**ADVISORY BOARD ON
RADIATION AND WORKER HEALTH**

**REVIEW OF NIOSH PETITION EVALUATION REPORT FOR
PETITION SEC-00136 DATED JULY 21, 2009,
ELECTRO-METALLURGICAL CORPORATION**

**Contract No. 200-2009-28555
SCA-TR-SEC2010-0010, Revision 1**

May 2011

Figure 1. Normal Score Plot of Operator Data

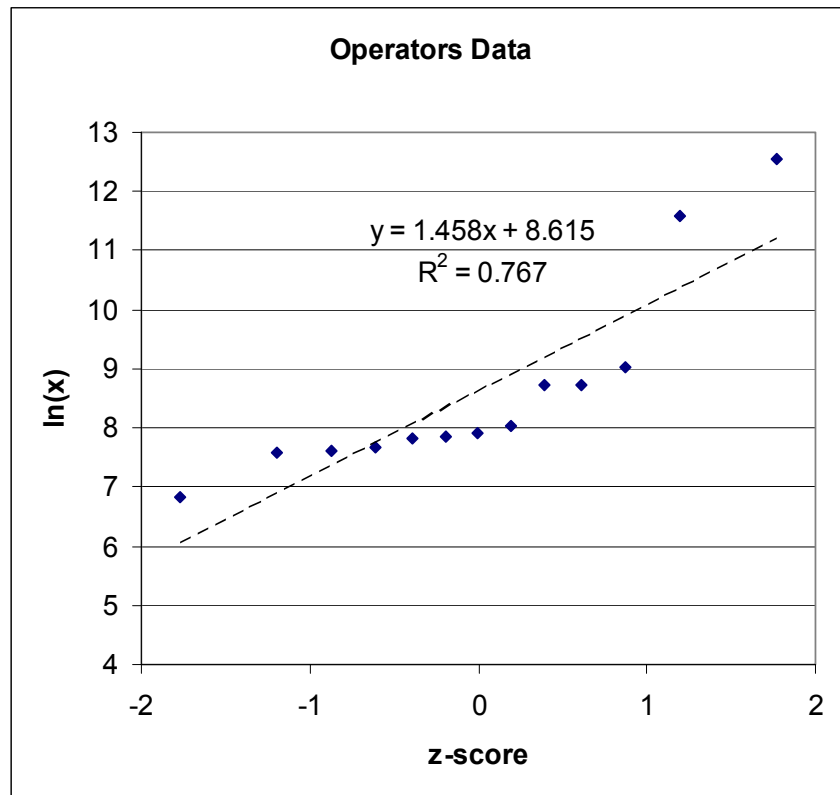
The three methods often yield very similar results when the sample size is over 30. For small samples, the three methods may yield different results. In the case of operator exposures, the sample size is N=13, a relatively small sample. The results of applying the three methods in this case are shown in Table 7. The three methods yield substantially different results for the 95th percentile, ranging from 60,661 dpm/calendar day for the NIOSH graphical method shown in Figure 1 up to 83,721 dpm/calendar day for the unbiased method. The MLE method yields a value in between, at 75,203 dpm/calendar day. The differences between the three methods are due to the different weight assigned to the two highest values. The unbiased estimate yields the highest estimate for sigma, because of the large magnitude of the squared deviations for these two extreme values. For the supervisors/laborers and other workers categories, agreement among the three approaches is much better, since the results are not significantly affected by extreme high-end values. The MLE method is generally preferred by statisticians over other methods if there are no missing values.

Figure 2. Normal Score Plots for 1944 and 1949 with Regression Lines

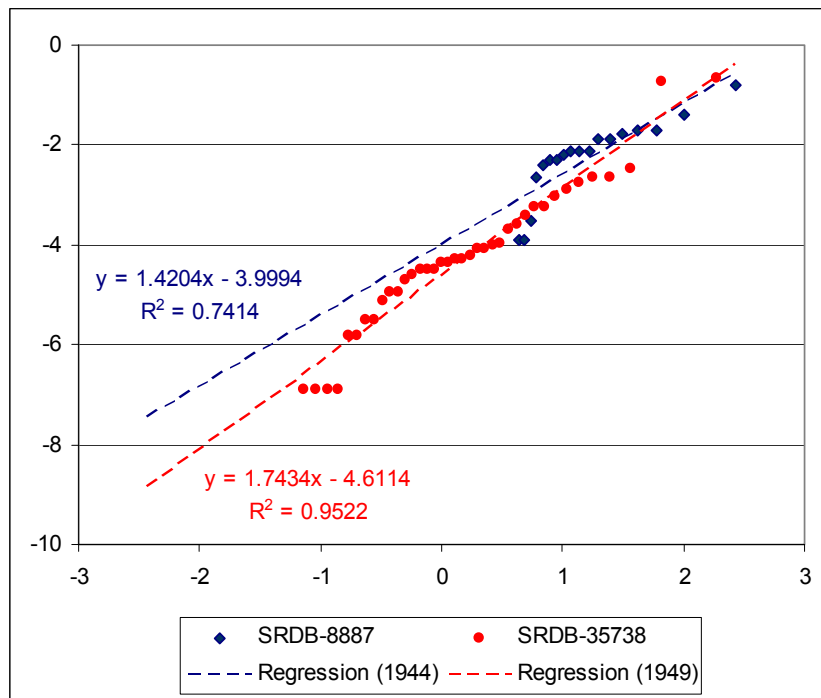
The normal score plots and regression lines in Figure 2 look similar for the 1944 and 1949 datasets. The regression coefficients provide estimates of the lognormal parameters μ (μ) and σ (σ) for each year. The estimated lognormal distributions have similar means and 95th percentiles, as shown in Table 10. The other lognormal parameters show larger differences. The largest differences for GM and GSD have opposite signs, indicating that these are offsetting differences. The differences between the two distributions are large enough to require further investigation, as described below.

Figure 3. Best Estimate and Approximate 95% Confidence Region for the Intercept (μ) and Slope (σ) of the Regression Lines for 1944 and 1949

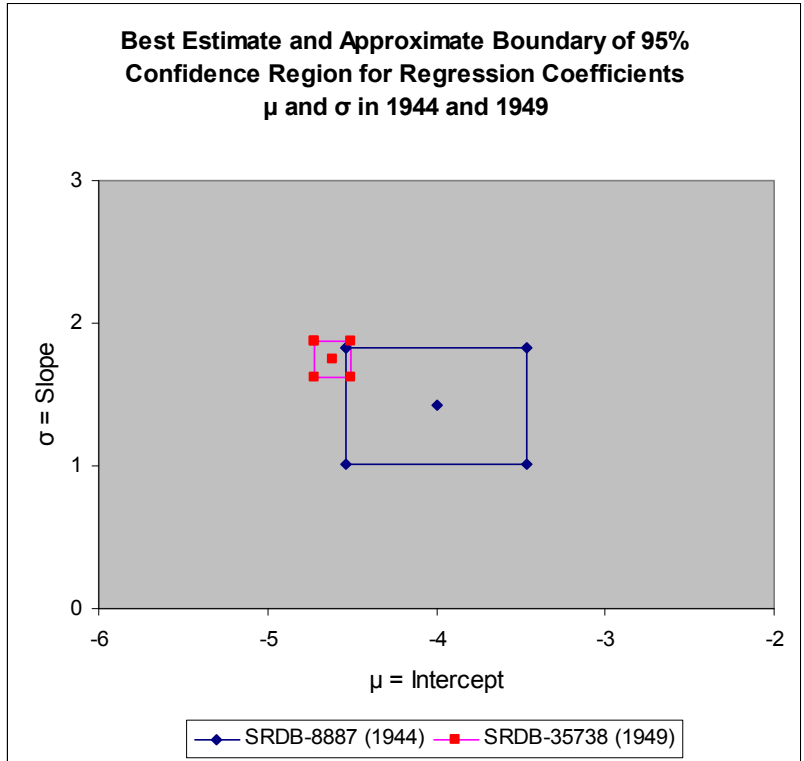
The approximate 95% confidence intervals for the regression coefficients are shown in Figure 3. The smaller size of confidence region in 1949 is due to the larger number of samples over the limit of detection. The actual confidence intervals for the regression coefficients have an elliptical shape, similar to the examples shown in Figure 4, stretching from the upper left corner to lower right corner of the rectangular regions shown in Figure 2. The negative slope of the major axis of the ellipses in Figure 3 indicates that there is a negative correlation between estimates of the slope and intercept of a regression line. This negative correlation accounts for the opposite signs of the differences between 1944 and 1949 for the GM and GSD noted in Table 10.

The slight overlap of the approximate 95% confidence intervals for the 2 years in Figure 3 provides statistical evidence that the regression lines for 1944 and 1949 are not significantly different.

Figure 5. Comparison of 95% Confidence Regions for General Air Sample taken on April 5, 1944, and July 26, 1944

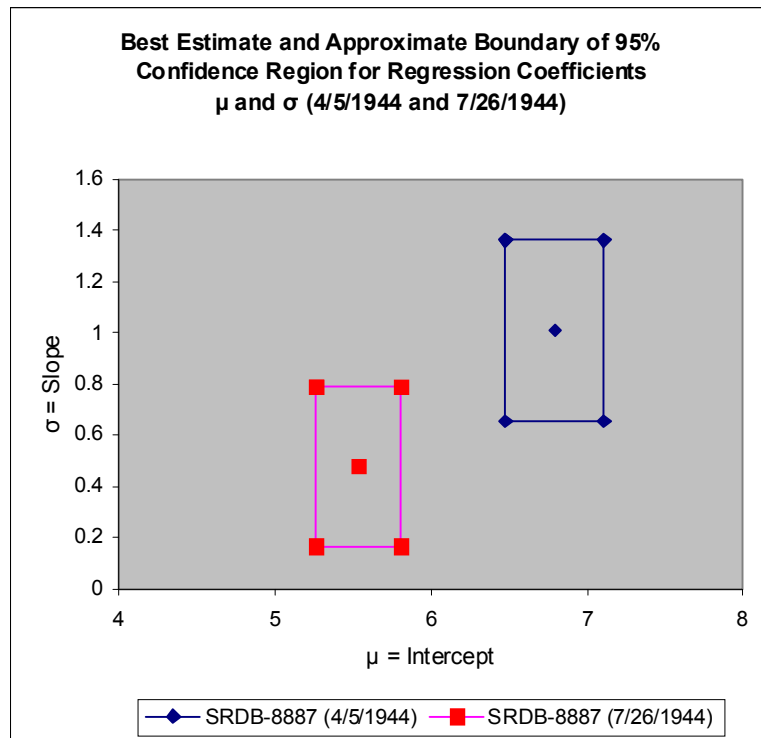
To further demonstrate that the two datasets are statistically different, the 95% confidence regions are compared in Figure 5. The large separation of the two confidence regions provides additional evidence that the two datasets are statistically different. This evidence does not support the NIOSH hypothesis that the process did not change over time prior to 1948. We recognize that this conclusion is based on small samples, but they represent all of the available information.
